Minutes of Pre-bid meeting held on 21.04.2015 at 15:00 Hrs for the tender for design, construction, supply and installation of a steel Pontoon with gangway at Terminal location at Erada on NW-5, Odisha.

Typical crane proposed for installation.

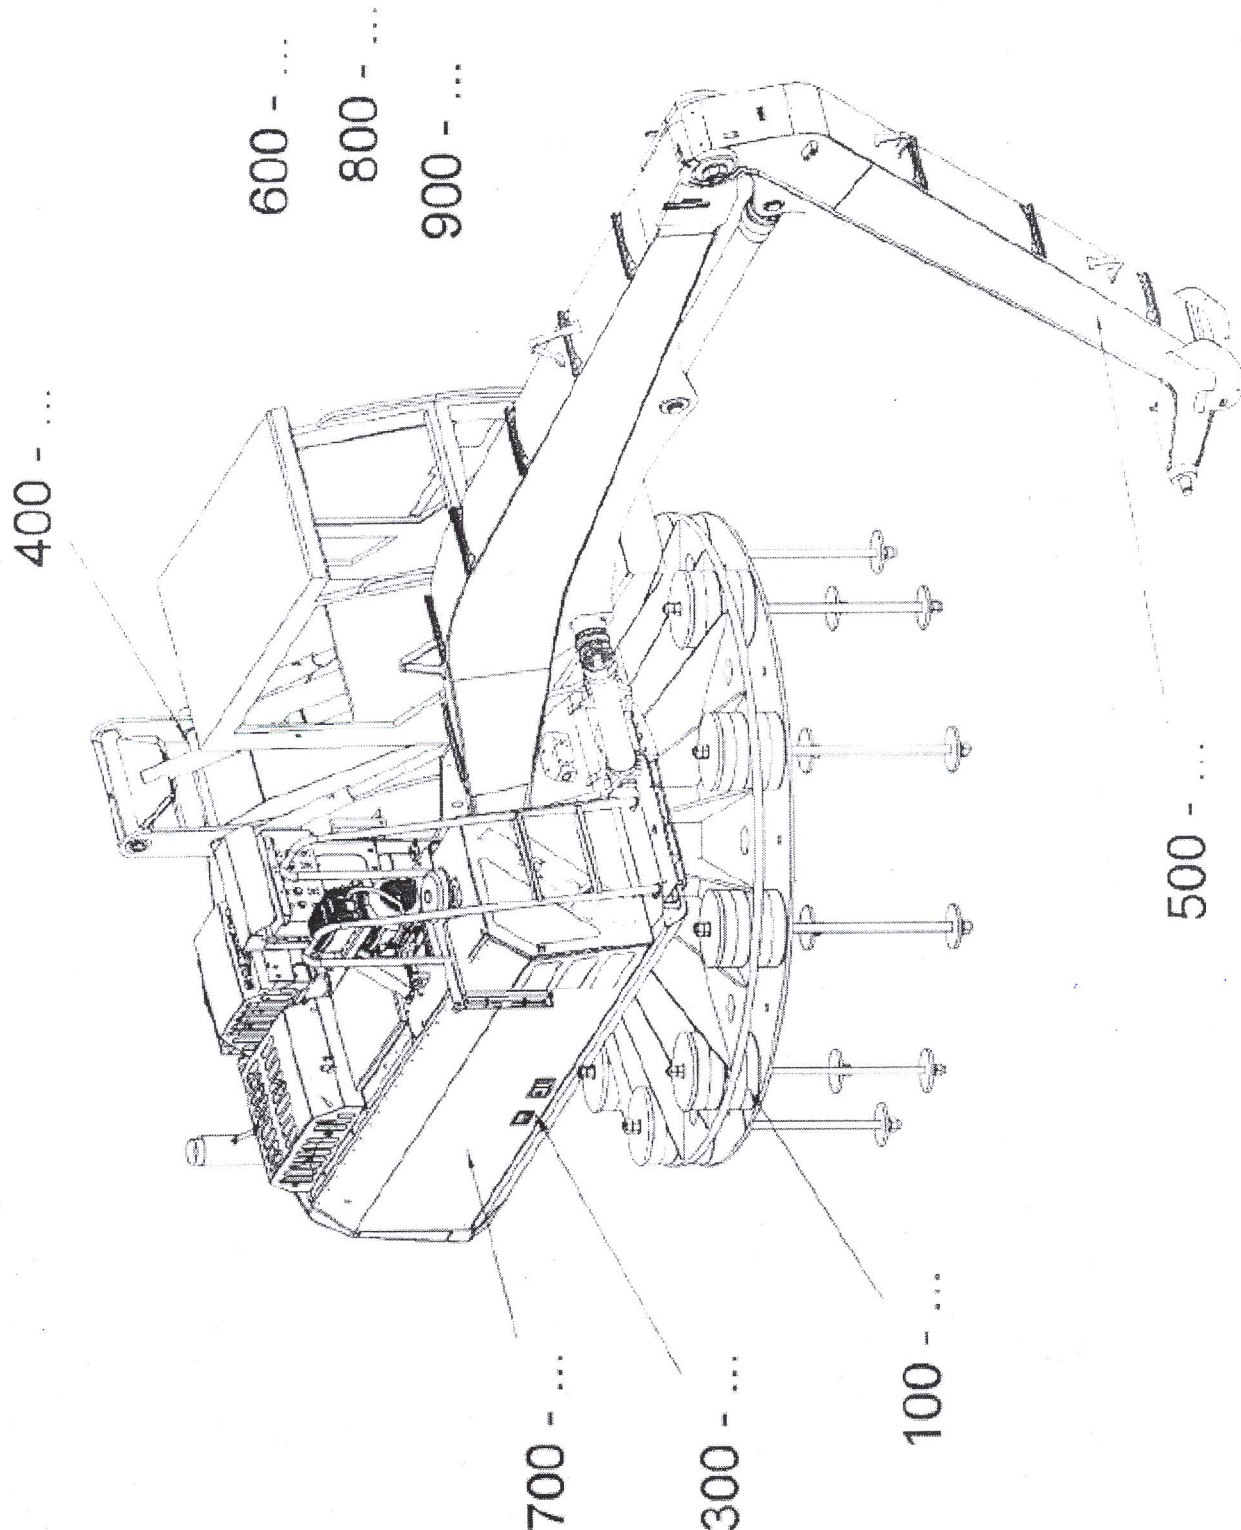
11		One of the bidders enquired that whether one or two cranes shall be installed and accordingly the requirement of calculating the trim and stability and fixing the dimension.	It is clarified that two cranes of maximum 5 ton capacity for loading/unloading having a variable boom length of 10 to 15m shall be installed on the centre line of the pontoon as the draft GA plan attached. The principal dimension as

mentioned may have variation of +/- 5% depending on trim and stability requirement. The trim and stability booklet of the pontoon in various operating condition of the cranes shall be prepared and got approved from the registering authority as per the provision of IV Act of 1917.
12.		One of the bidders enquired about the mode of transport of Pontoon either by waterway or road.	It is suggested to the bidders to visit the site to assess the feasibility of transporting by waterway or road and also construction of pontoon at the terminal site.
13	Clause. 8.0 (Page .6)	One of the bidders requested that date of submission of bids may please be extended for one week	The last date of submission of the bids now shall be upto 17 hrs. on 14 th May 2015 and the bids be opened on 15 th May' 2015 at 11:30 hrs.
